Access Compliance Report

Public Rights-of-Way

(Curb Ramps)

Intersection ID: 28629	Main Street: DEARMON_RD	Cross Street: EAGLE_CREEK_DR	Location: E
ADA ID: ACB2B6BA8E61	Ramp Type: Perp	Initial Pass/Fail: Fail	Overall Compliance: No
			Severity Score: 46.25

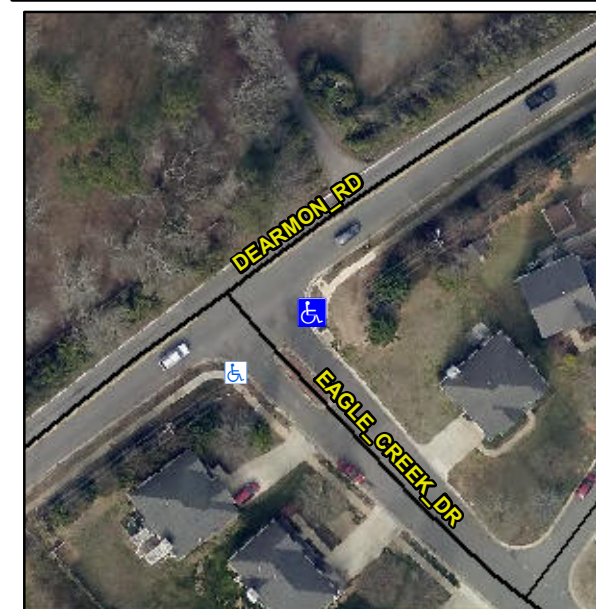
R304.5.1, R304.2.2, R304.5.3

Compliance	Description	Data	Compliance	Description	Data
N/A	Ramp Length (in)	65.0	No	Ramp Slope (%)	14.6
No	Ramp Width (in)	47.0	No	Ramp XSlope (%)	6.7
N/A	Flare Type LT	N/A	N/A	Flare Type RT	N/A
N/A	Flare Slope LT (%)	N/A	N/A	Flare Slope RT (%)	N/A
N/A	Flare Traversable LT?	N/A	N/A	Flare Traversable RT?	N/A
N/A	Landing Length (in)	N/A	N/A	DWS Provided?	N/A
N/A	Landing Width (in)	N/A	N/A	DWS Contrast?	N/A
N/A	Landing Slope (%)	N/A	N/A	DWS Length (in)	N/A
N/A	Landing X Slope (%)	N/A	N/A	DWS Full Width?	N/A
N/A	Landing Curb? (Y/N)	N/A	N/A	DWS Offset (in)	N/A
N/A	Shared Landing?	N/A			
N/A	Gutter Ponding?	N/A	N/A	Gutter Slope (%)	N/A
N/A	Gutter Lip Ht (in)	N/A	N/A	Gutter X Slope (%)	N/A
N/A	Painted X Walk1?	No	N/A	Painted X Walk2?	N/A
	X Walk 1 Direction	To SW		X Walk 2 Direction	N/A
N/A	X Walk 1 Width (in)	N/A	N/A	X Walk 2 Width (in)	N/A
	X Walk 1 Slope (%)	8.2		X Walk 2 Slope (%)	N/A
	X Walk 1 X Slope (%)	2.7		X Walk 2 X Slope (%)	N/A

Remove & Replace Entire Ramp.
